Sirius SSD Modification 1 (SSD 10384_Mod 1): proposed tree removal

Sirius - Tree Removal on Gloucester Walk

This letter is prepared to provide comment on the existing Sirius eastern basement retaining walls design and condition and to also comment on the stability of Trees T50 and T51 on Gloucester walk due to the required basement wall structural upgrade and proposed basement construction works.

Tree 50: Plane Tree root penetration at wall floor internal junction

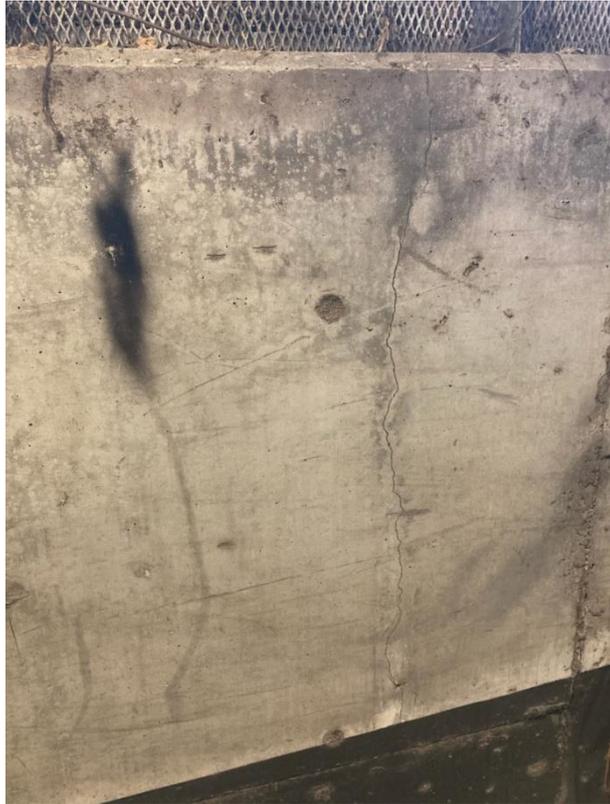
We note the existing retaining walls are of age and have been compromised by Tree 50 and 51. At Tree 50, the tree roots have penetrated the walls inducing forces onto the wall as well as compromising the integrity and waterproofing of the wall. At tree 51, the wall displays a vertical crack at the centre line of the tree trunk indicating the tree has imparted significant lateral pressure on the wall and caused the wall to fail in horizontal bending. This crack in the wall is at least 1 to 1.5mm in width indicating structural failure of the wall. We note the wall at this location also presents a 30mm lean into the basement. The lean is indicative of flexural failure at the base of the wall, or instability of the wall as a result of the added induced lateral pressure of the tree root system.

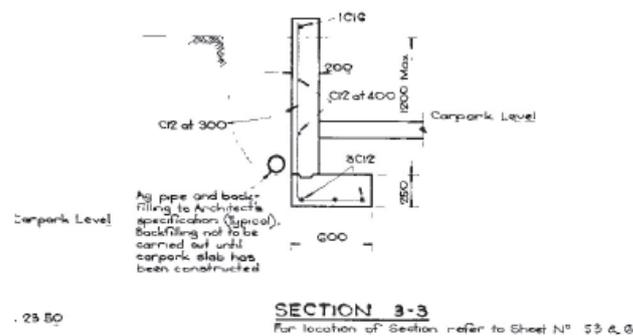
Section 4-4 indicates a wall height of 2250mm having a footing of 1200mm wide. In accordance with AS4678-2002 the footing is to have a width of 1700mm minimum. The wall is therefore deemed to be unstable in accordance with the code requirements.

Typical Wall section South of Grid 108.5 at Tree 50

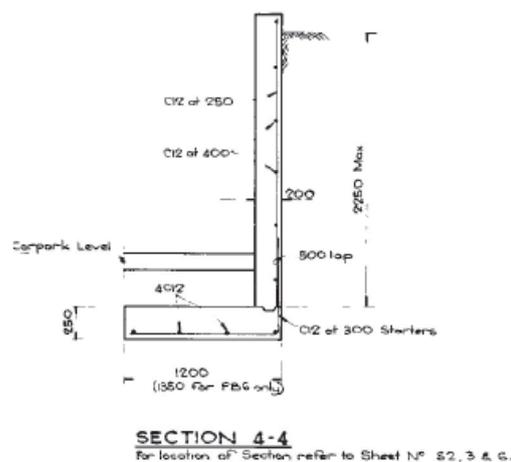
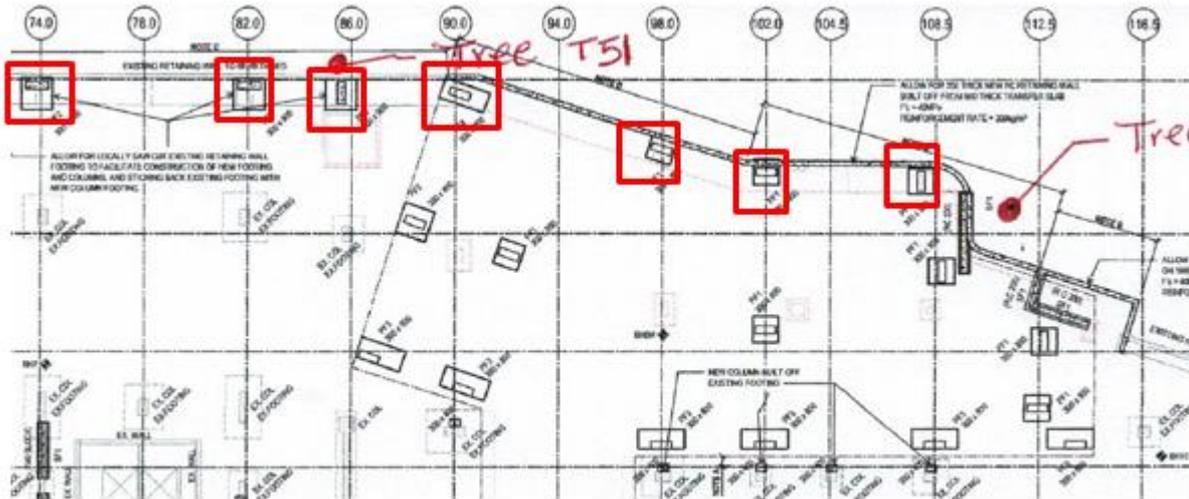
The existing retaining walls adjacent to trees 50 and 51 have narrower footings than required as specified in AS4678-2002 Earth Retaining Structures.

The 2 sections below indicate the construction of the existing walls and footings at tree 50 and 51.

New Works Plan showing new pad footings clashing with existing RW footings.

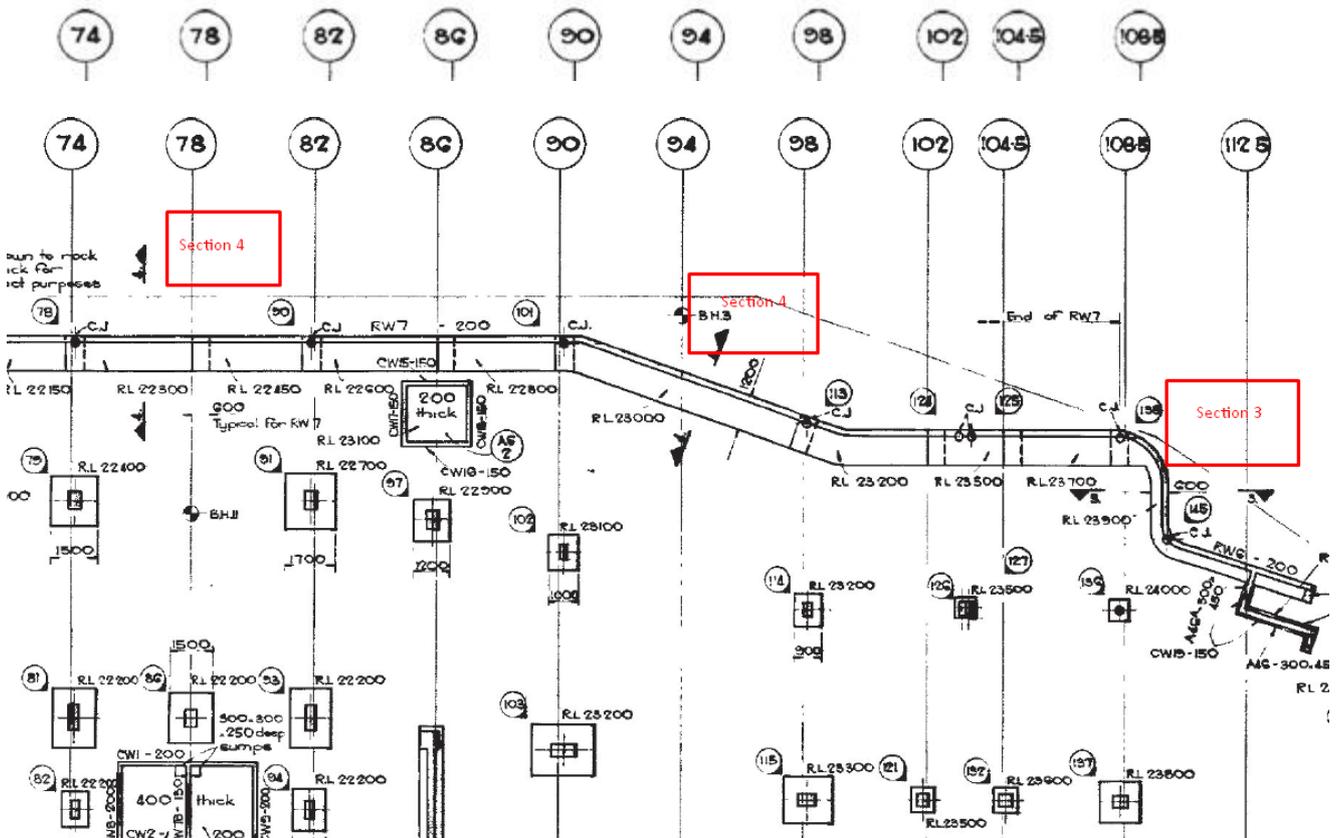
Further as can be seen in the below sketch, pad footings need to be constructed for the future SoHo structure and podium above and these new footings clash with the existing retaining wall footing locations. Therefore, in order to construct the new footing pads the wall footings will need to be demolished, further making the retaining wall unstable.

Tree 50 Updated Podium design showing vertical support structure under clashing with the existing Section 3 Retaining Wall.

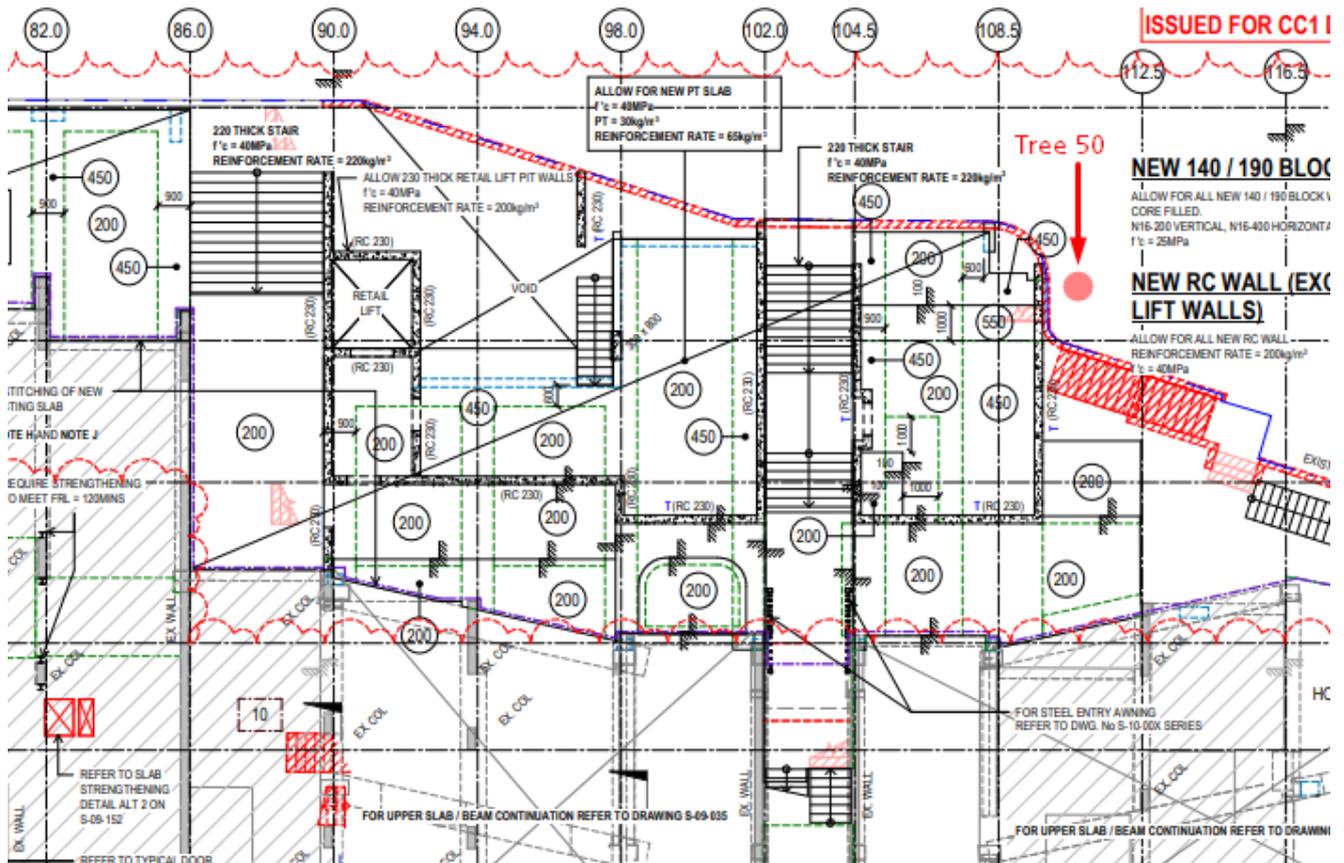
To upgrade the building to meet current standards and good building practice (waterproofing, stability etc), which is required in order to structurally certify the completed project, the retaining walls will require removal and re-construction which will impact on the stability of tree 50 and 51.

Tree 50 Updated Podium design showing vertical support structure under clashing with the existing Section 3 Retaining Wall.

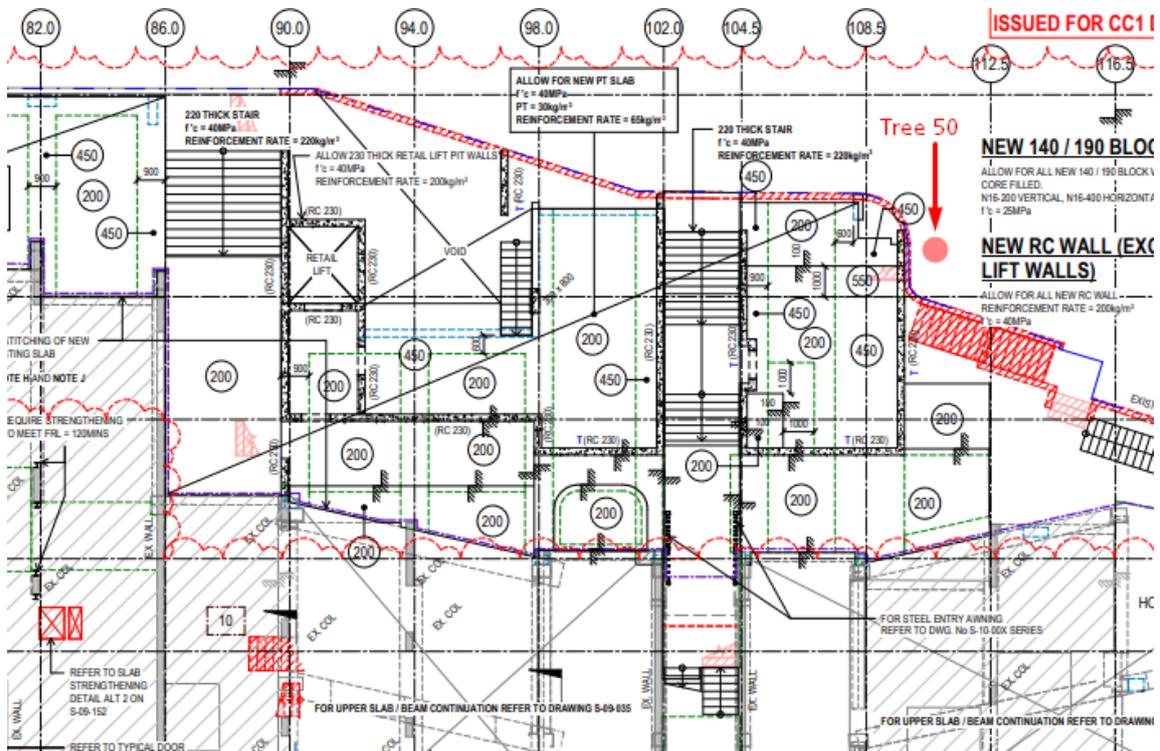
With the required removal of the backfill at the tree locations and wall re-construction, the trees would be unstable. Refer to the Arborist report.
